## MISSISSIPPI DEPARTMENT OF ENVIRONMENTAL QUALITY

**RE: CCC Comments for AMNP**

Thank you for providing comments on MDEQ's 2025 Annual Monitoring Network Plan. Please see MDEQ's response to the comments from the addressed comment letter, CCC Comments for AMNP dated Thursday, June 27, 2024.

#### **Error in the latitude and longitude coordinates**

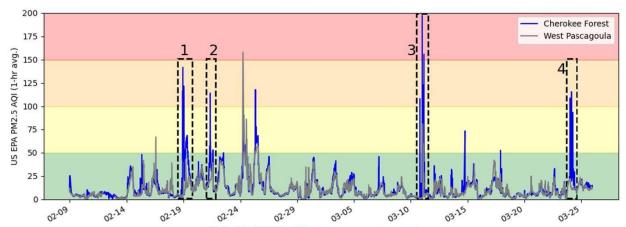
The Latitude and longitude of Cherokee Forest in Table 7 of the Appendix is not correct. It should be 30.3524, 88.5090 instead of 30º35'24", 88º50'90".

It appears that this comment stems from a misinterpretation of our formatting. The latitude and longitude of Cherokee monitoring station (as well as the other stations) in Table 7 of the Appendix is to be read as "30.3524, -88.5090" [which equates to 30° 21' 8.6394", -88° 30' 32.4"] instead of "30°35′24", 88°50′90" and has been corrected in the network plan.
